EST2: 2-DACT Intermittent Faults

Introduction

Figure 1: Wiring

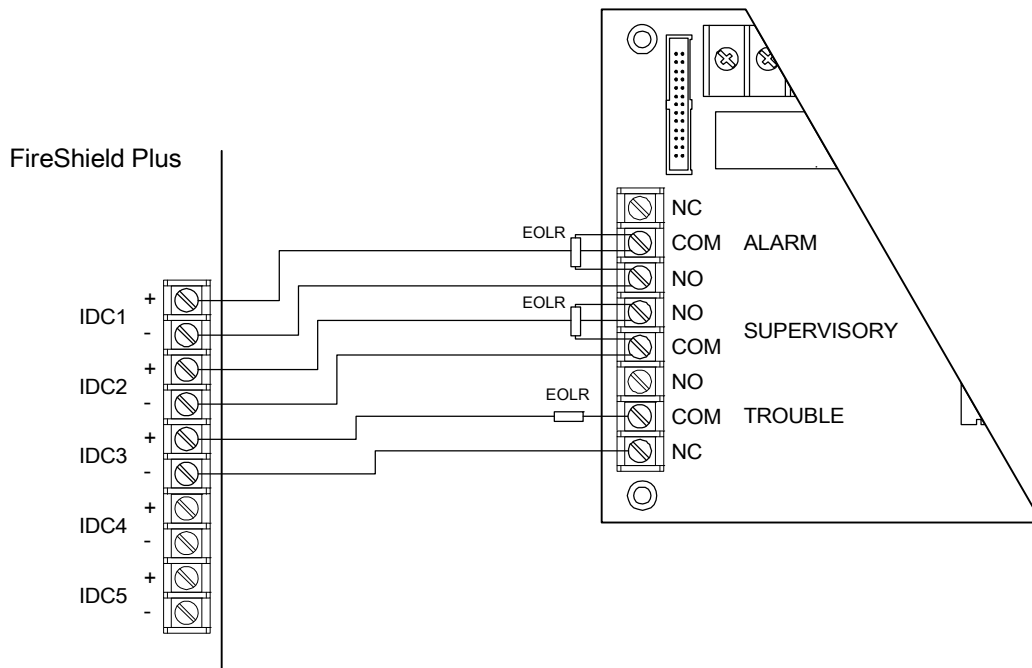
Technical Support has received numerous calls on intermittent fault conditions related to dialer communications and supervision on EST2 systems. These faults are characterized by a "DIALER IS MISSING 0012" event which occurs randomly at system start and reoccurs every 1 to 3 days. The fault duration is momentary and activates and restores immediately. All other dialer functions perform as intended and it should be emphasized that these faults do not inhibit any life safety functions.

For installations requiring immediate availability, we will provide a FireShield Plus panel with dialer (model FSP502RD or FSP502GD) in lieu of your 2-DACT order. The FireShield Plus provides a Panel Op Mode FACOM option that configures the panel to operate as a dialer for fire alarm control panels that do not have a dialer.

Wire the FireShield Plus control panel to the 2-MCMx controller as shown in Figure 1 below. Use P/N EOL-4.7 for the EOLR.

1. Set the FSP Panel Op Mode option for FACOM.
2. Set the IDC1 Zone Type option for Alarm-Unverified (default).
3. Set the IDC2 Zone Type option for Supervisory.
4. Set the IDC3 Zone Type option for Monitor.
